MISSION POINTE II, MULTIFAMILY

SUMMARY

Staff recommends approval of the MPL2023-10002 subject to the conditions below:

SITE PLAN

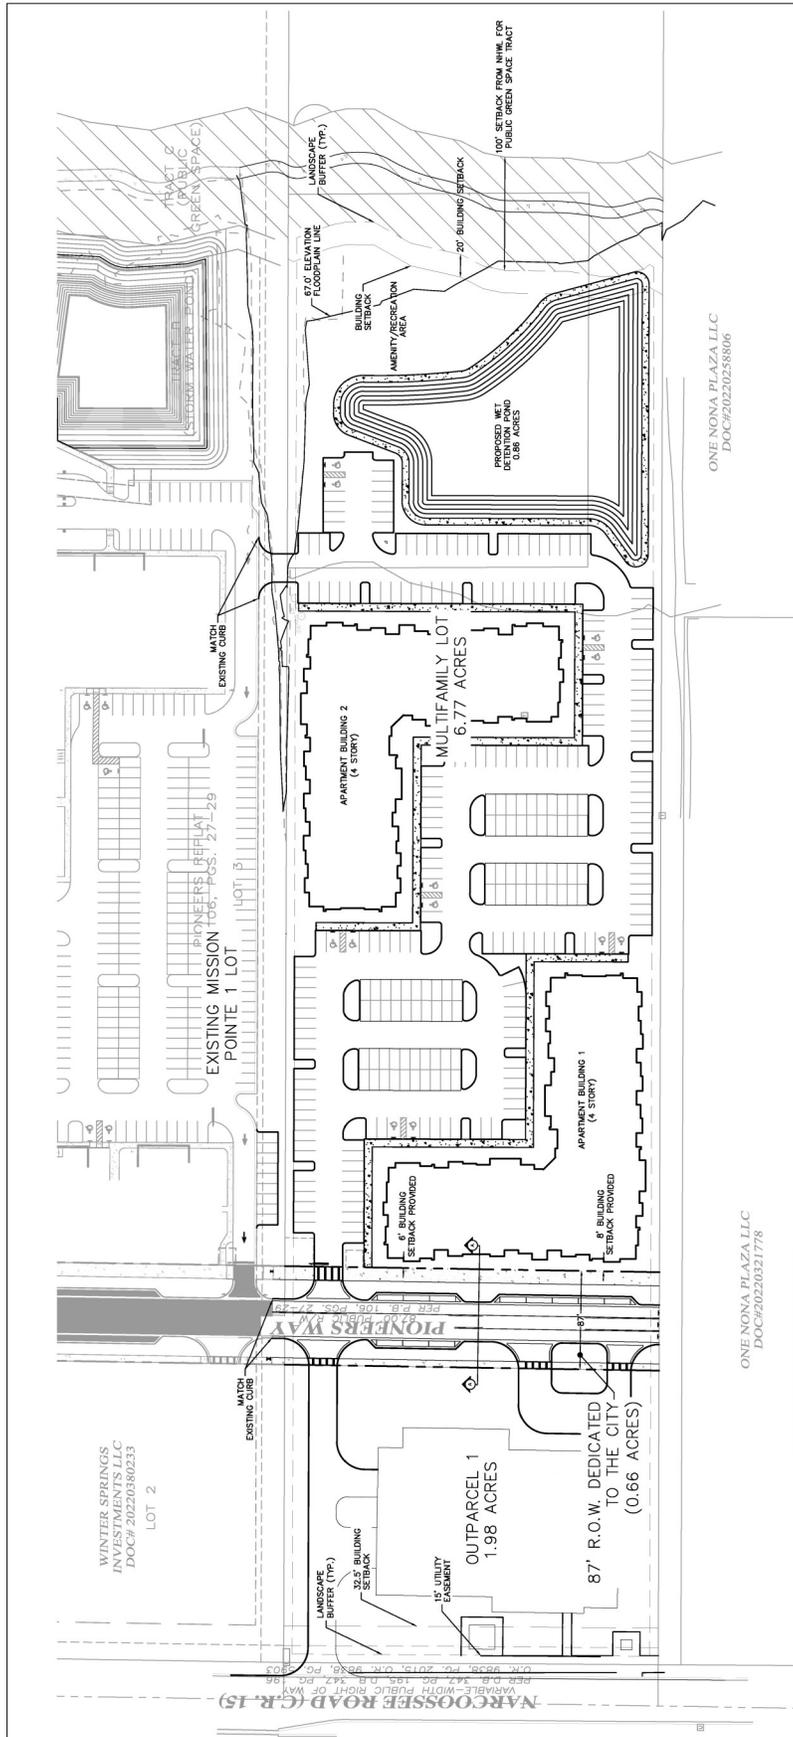
6. Pioneers Way (North-South Road)
 - a. The curb cut on Pioneers Way as shown on this plan is not permitted. The site plan must be revised to comply with LDC Ch. 61, Part 2 requirements; the revision can be approved via Final Site Plan Determination. The site plan must ensure there is enough driveway width or curb overhang space for a denied-entry three-point turn at the gate.

7. Entryway Drive Aisle: The drive aisle from Narcoossee Road to Pioneers Way must appear similar to a street, with sidewalks and street trees. The site plan must be revised to show these features, as well as a typical section diagram.

LANDSCAPE PLAN

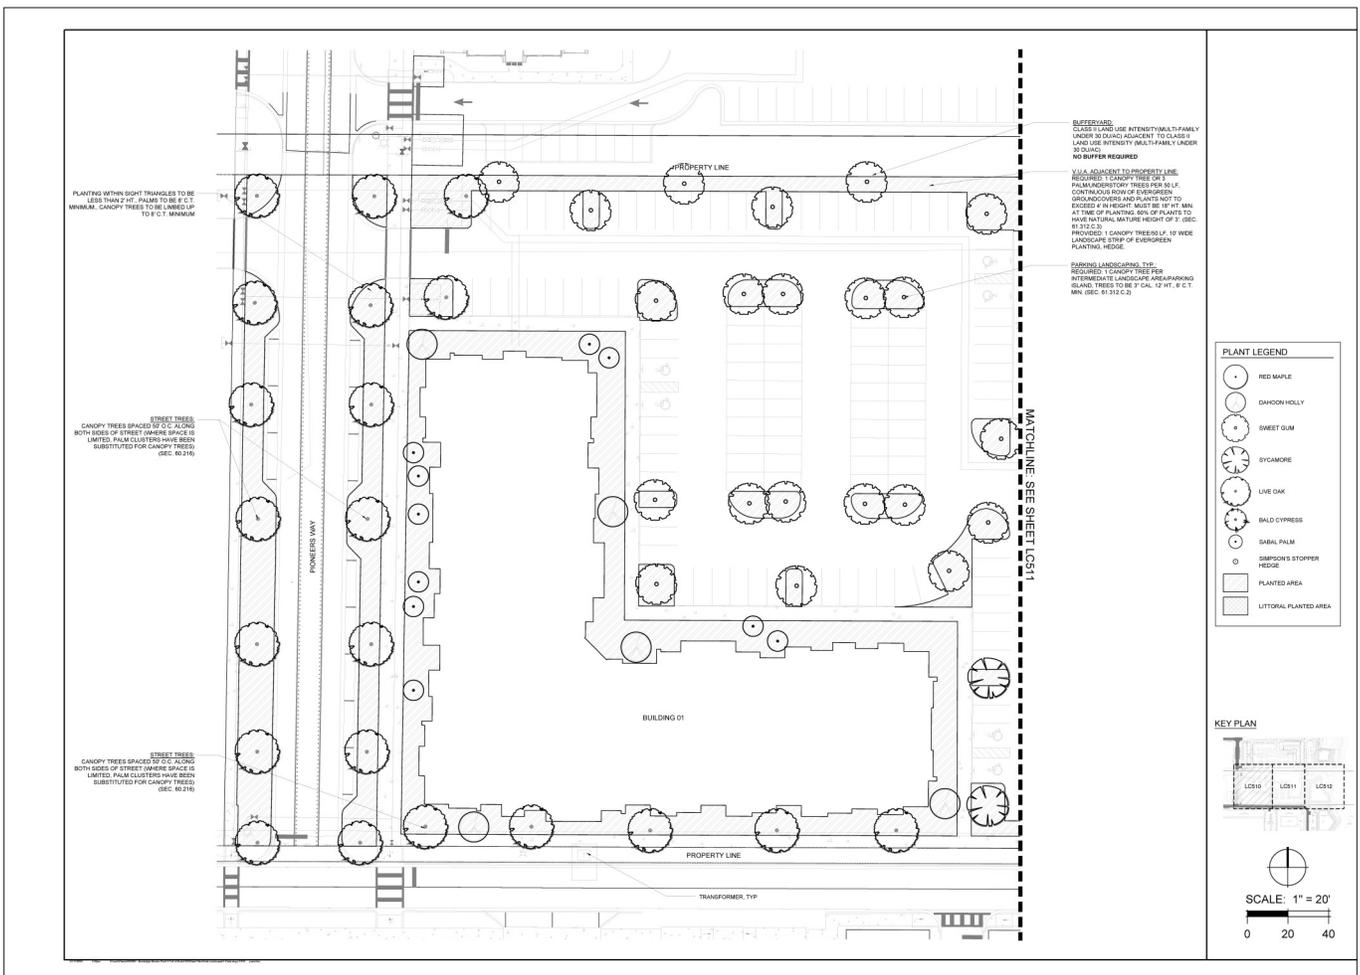
6. Street trees are also required on both sides of Pioneers Way. Street trees must be canopy trees, palms are not an acceptable street tree and reference to such should be removed from the plans.
